# **Geotechnical Investigation**

## **Proposed Residential Development**

4386 Rideau Valley Drive  
Ottawa, Ontario

**re: Geotechnical Response to City Comments  
Proposed Residential Development  
4386 Rideau Valley Drive, Ottawa, Ontario**

# Figure 6 - Section C - Existing Conditions - Static Loading

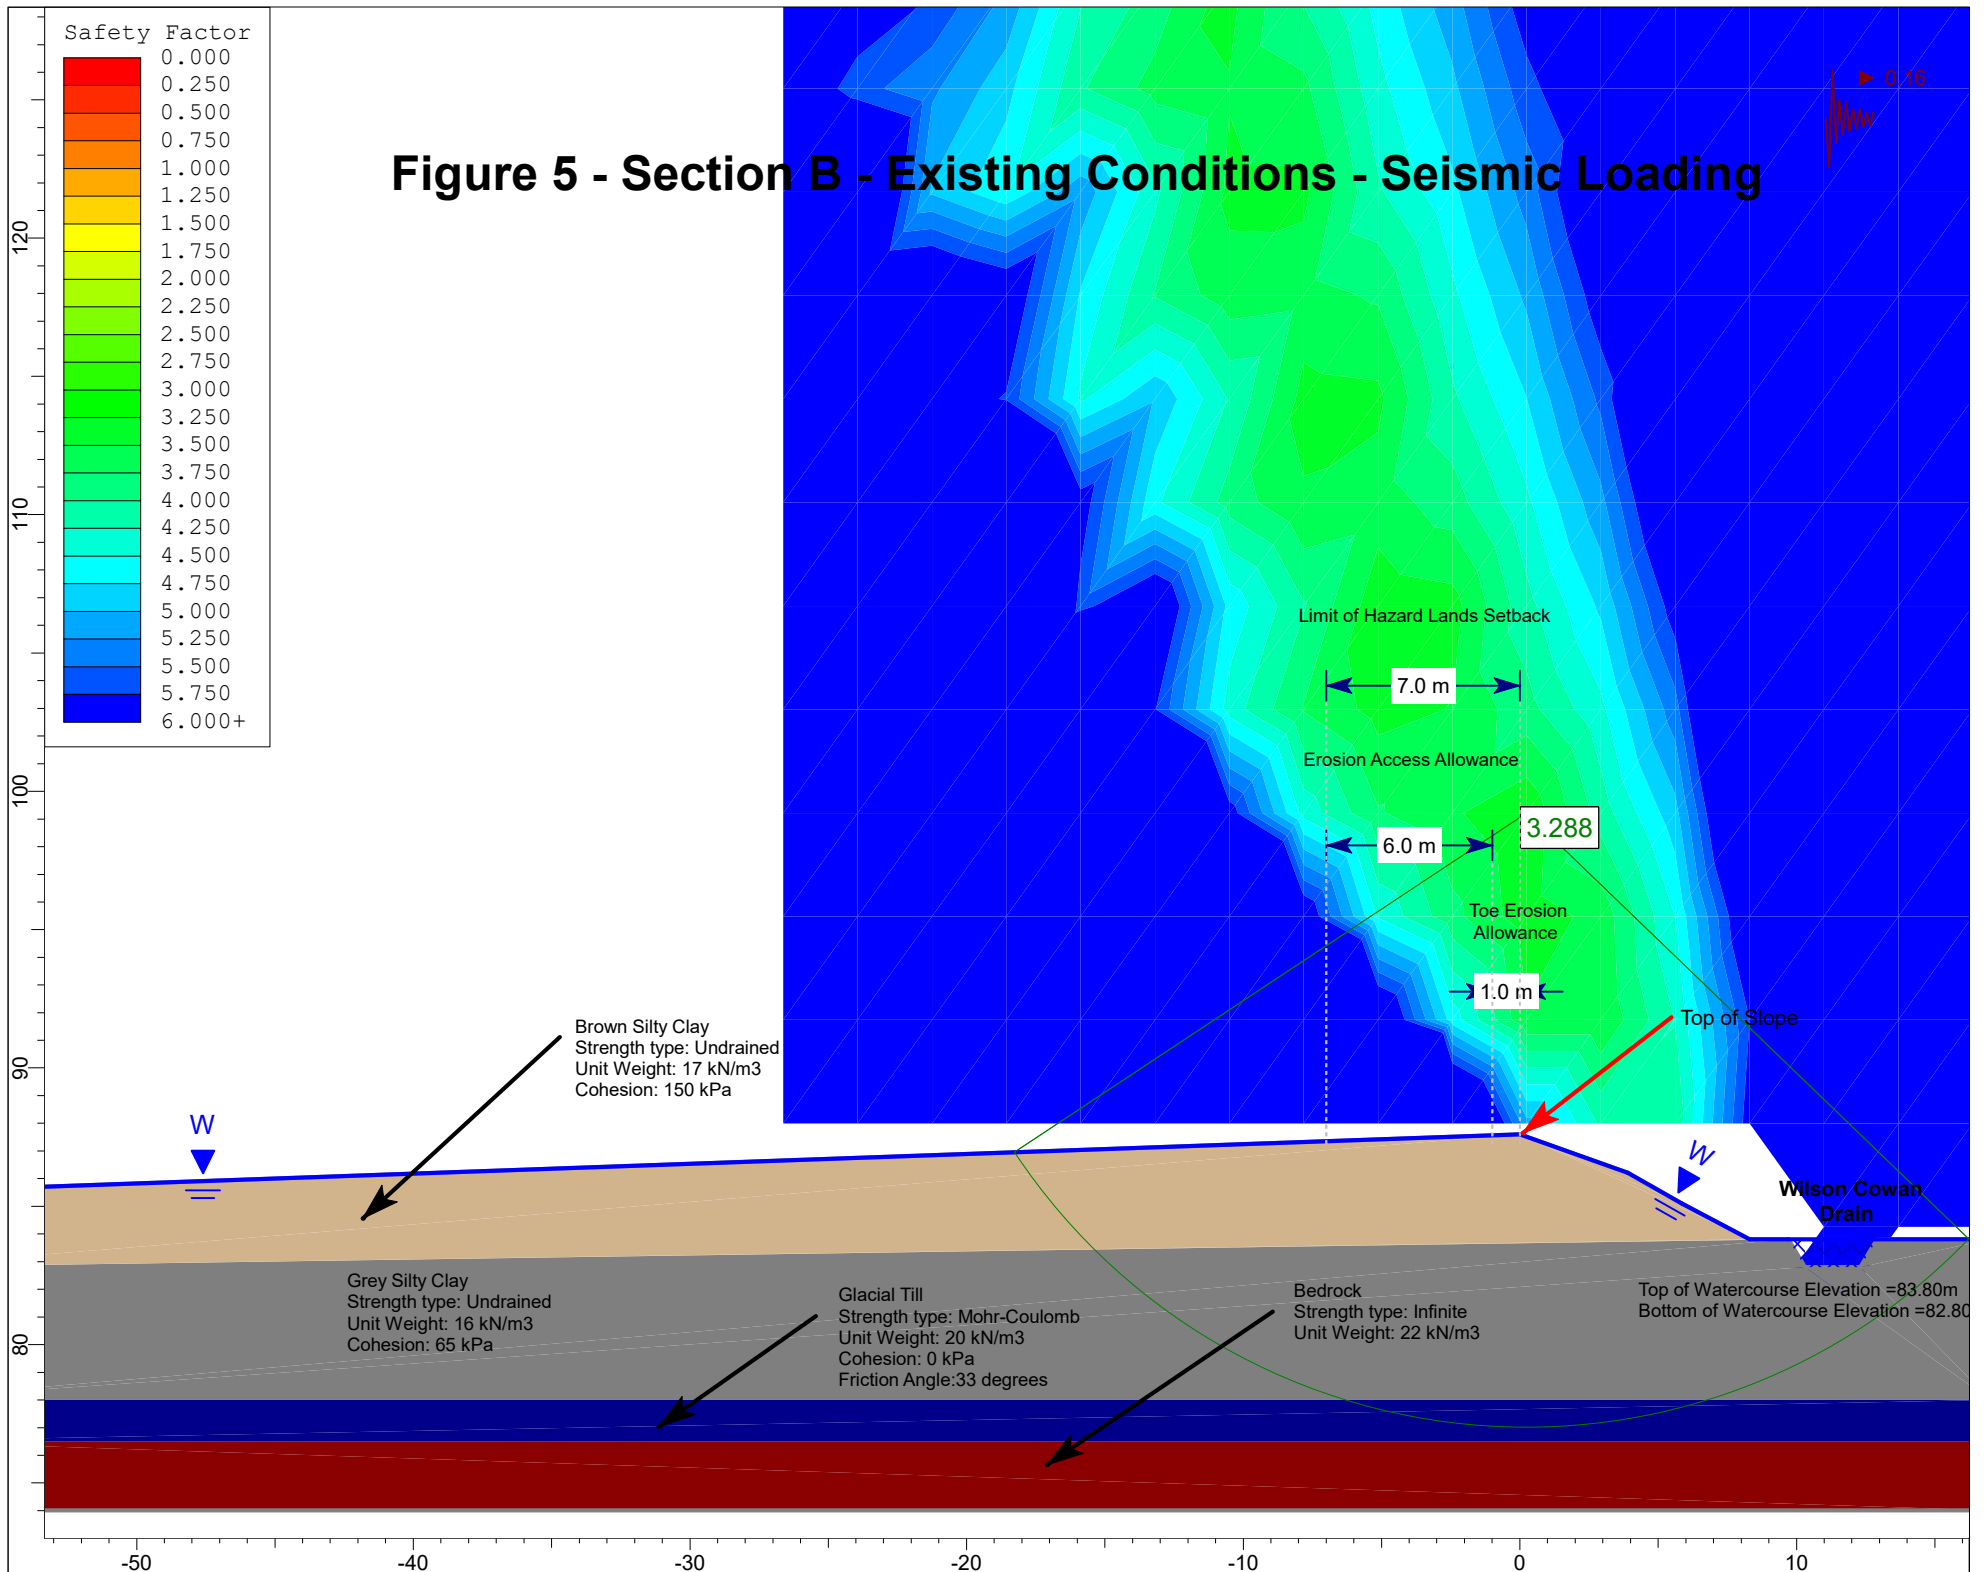
*The soil annotations on Figure 3 appear to be floating.*

Noted. The annotations for soil layers in Figure 3 have been modified in the above-mentioned revised report.

# Figure 7 - Section C - Existing Conditions - Seismic Loading

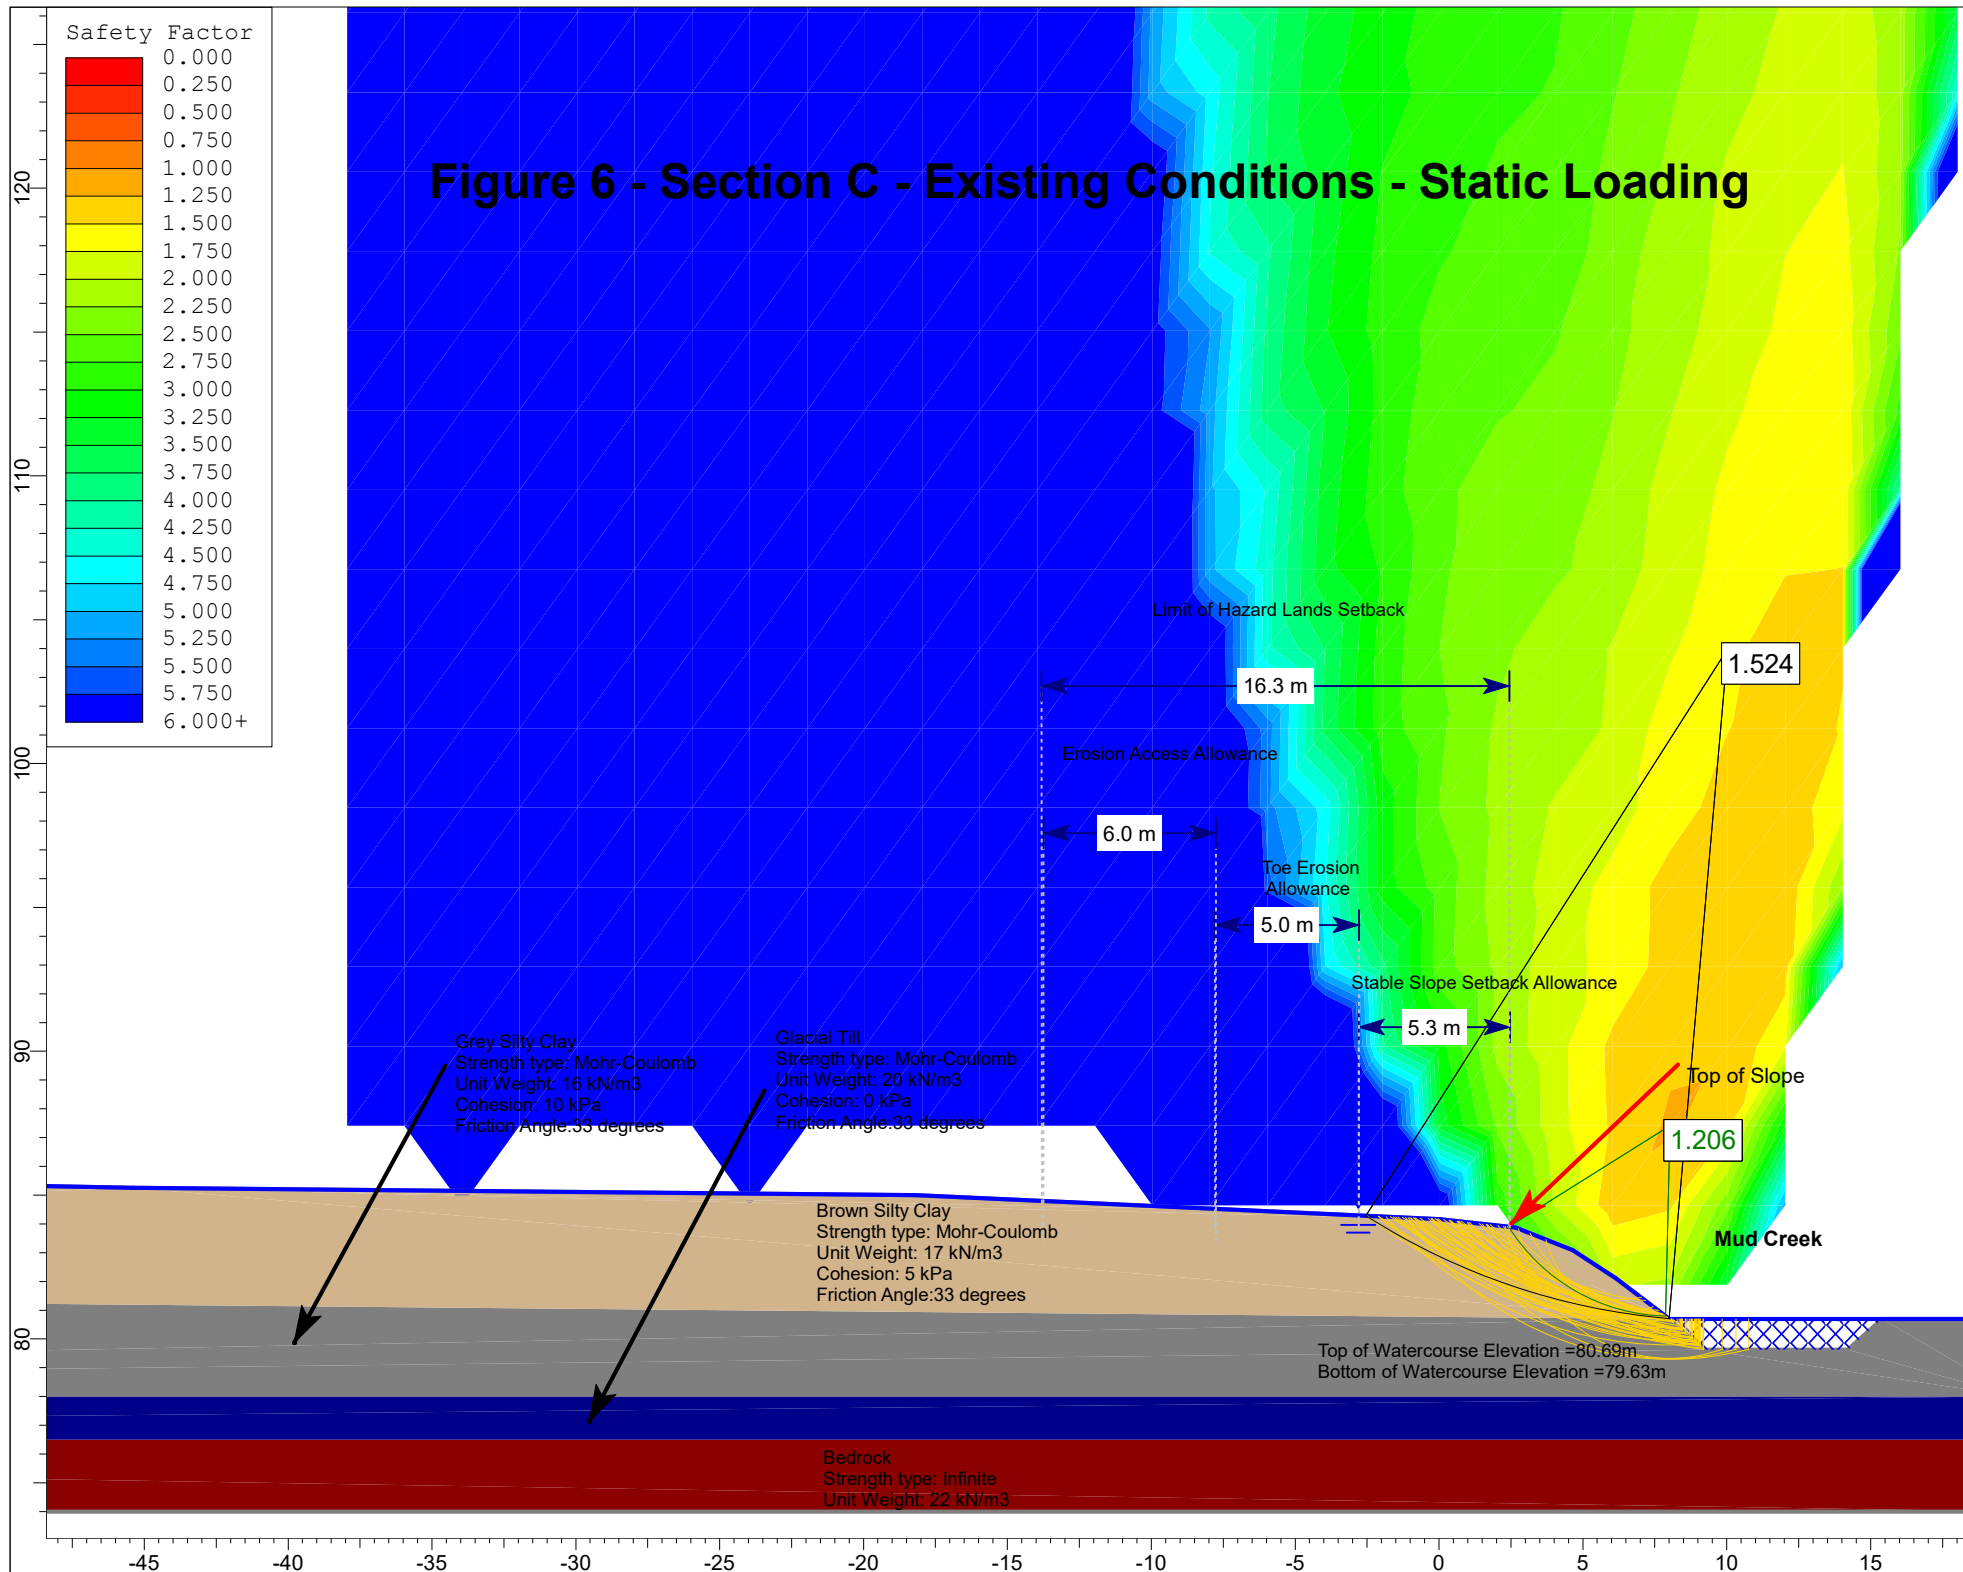
*Please include bathymetric survey data used for Figure 4 (amongst others).*

The bottom elevations of the watercourses at the studied cross sections has been determined using a high precision GPS, during our site visit to review the slope conditions. These elevations have been added to the slope cross sections included in the revised geotechnical report referenced above.

Figure 1. Criteria for evaluating liquefaction susceptibility of fine-grained soils (Bray et al. 2004).

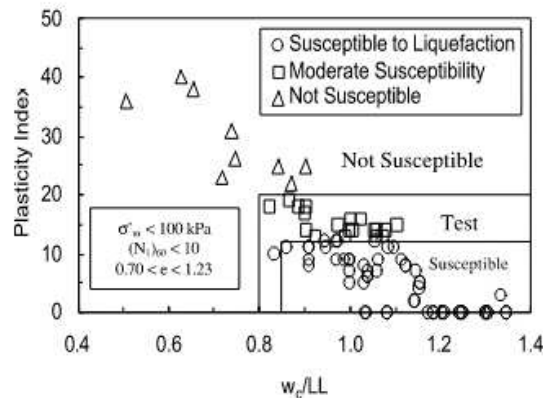
**Comment 2.27**

The soils encountered at the subject site consist of silty clays, which are cohesive in nature. These soils were evaluated for liquefaction susceptibility in accordance with the criteria prepared by Bray et al. 2004 which determines that all soils with a plasticity index exceeding 20% are not liquifiable (Figure 1). In general, the plasticity index results completed on samples taken from the silty clay layer were found to be above 20. Therefore, the encountered soils are not susceptible to liquefaction. Reference should be made to subsection 5.4- Design for Earthquakes in the abovementioned revised geotechnical report, for further details on liquefaction susceptibility at the subject site.
